# UNITED STATES PATENT AND TRADEMARK OFFICE

APPLICATION NO.	FILING DATE	FIRST NAMED INVENTOR	ATTORNEY DOCKET NO.	CONFIRMATION NO.
10/657,954	09/09/2003	Michael Crissy	EPH / 35	3045

**Office Action Summary**

# **ATTACHMENT 1**

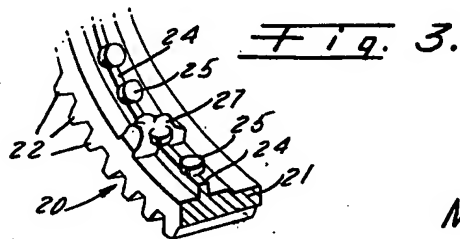
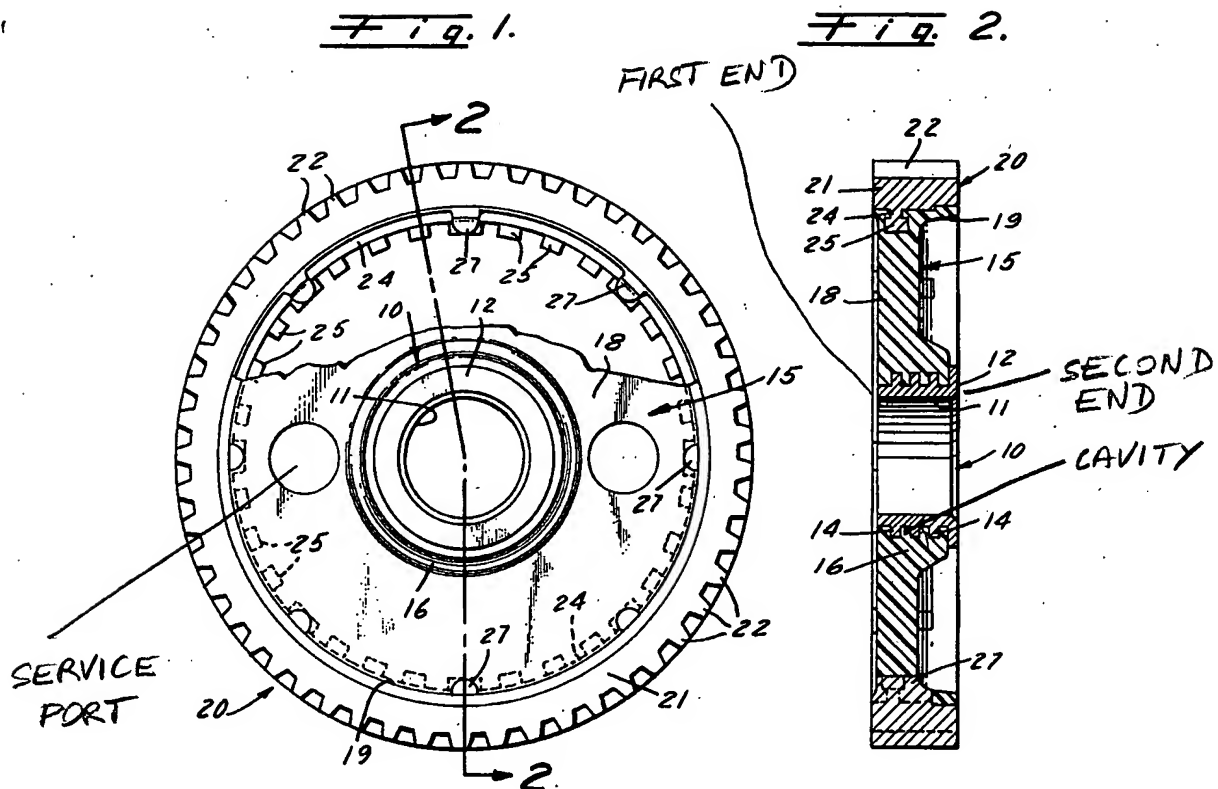
Regarding claim 1, Wells teaches a coupling structure mountable to a rotatable shaft (not shown) comprising: a polymer hub 18 having a plurality of service ports (unnumbered in Fig. 1. See Attachment 1); and a metallic insert 10 disposed radially inward from said polymer hub 18,

said metallic insert 10 including a tubular sleeve 41 extending between a first end (Att. 1) capable of being mounted to the rotatable shaft and a second end (Att. 1) opposite said first end, and an annular insert flange 12 (Fig. 2) projecting radially outward from said second end, said insert flange 12 being accessible through said plurality of service ports (Att. 1) for applying a force to said insert flange 12 capable of removing the coupling structure from the rotatable shaft when mounted thereto.

Regarding claim 8, said sleeve 11 includes at least one annular concavity (unnumbered). The concavity is located between two teeth 14. See Att. 1) filled with material from said polymer hub 18 for preventing relative rotation between said metallic insert 11 with said polymer hub 18.

Regarding claim 17, Wells' sleeve 11 includes at least one annular concavity (Att. 1) filled with material from said polymer hub 18 for preventing relative rotation between said metallic insert 11 with said polymer hub 18.

# **ATTACHMENT 2**

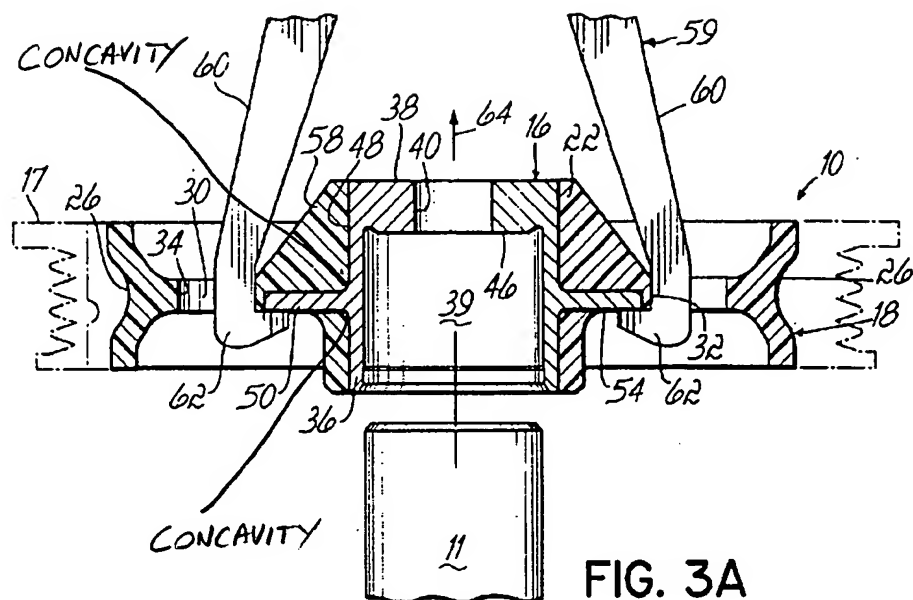
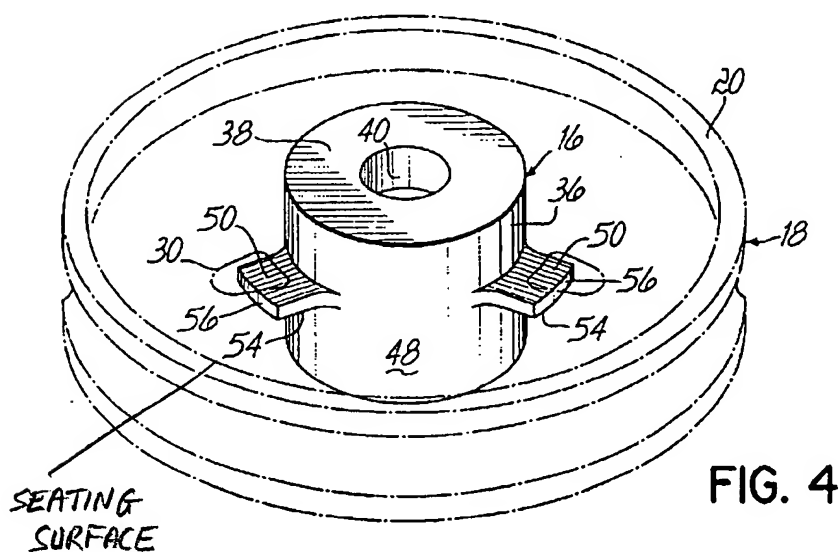
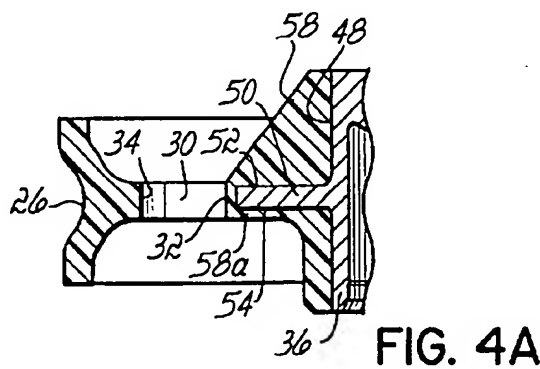
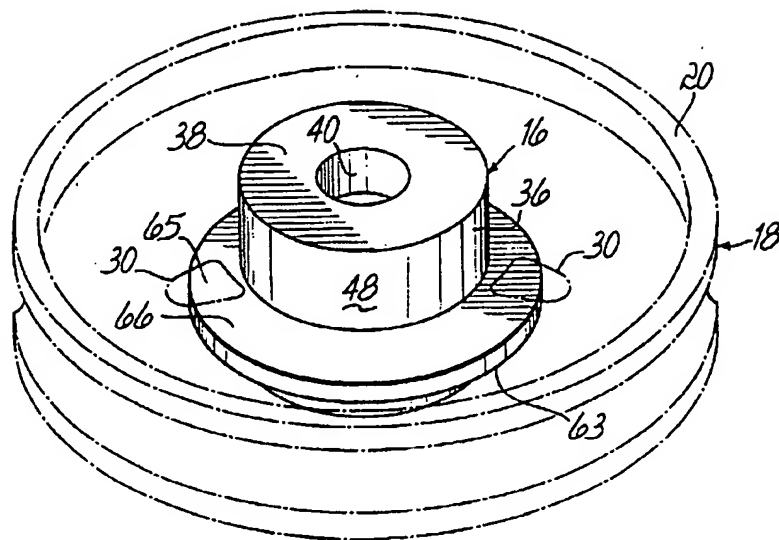
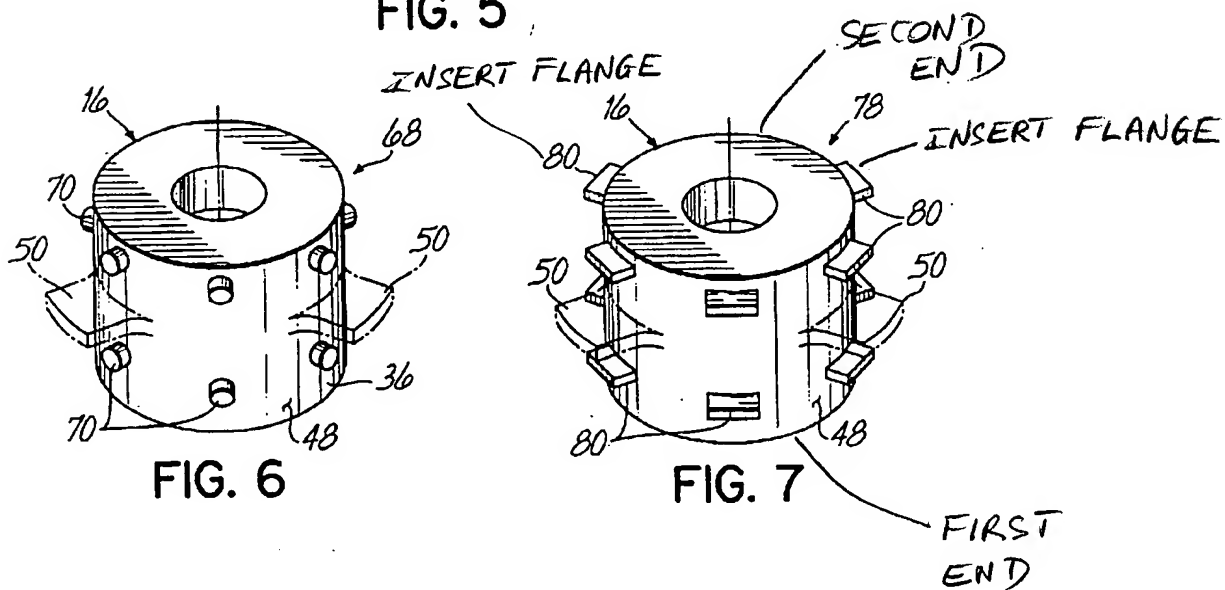
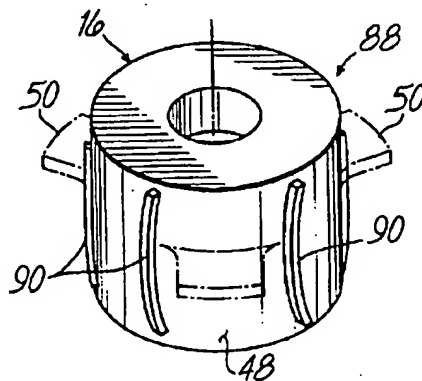
Regarding claim 8, said sleeve 48 includes at least one annular concavity (unnumbered. See Attachment 2) filled with material from said polymer hub 18 for preventing relative rotation between said metallic insert 16 with said polymer hub 18. Note that *Webster's II New Riverside University Dictionary*, 1994, defines "concavity" as "a concave surface, structure, or line." Thus, Nichols' concave surface or line "reads on" Applicant's "concavity."
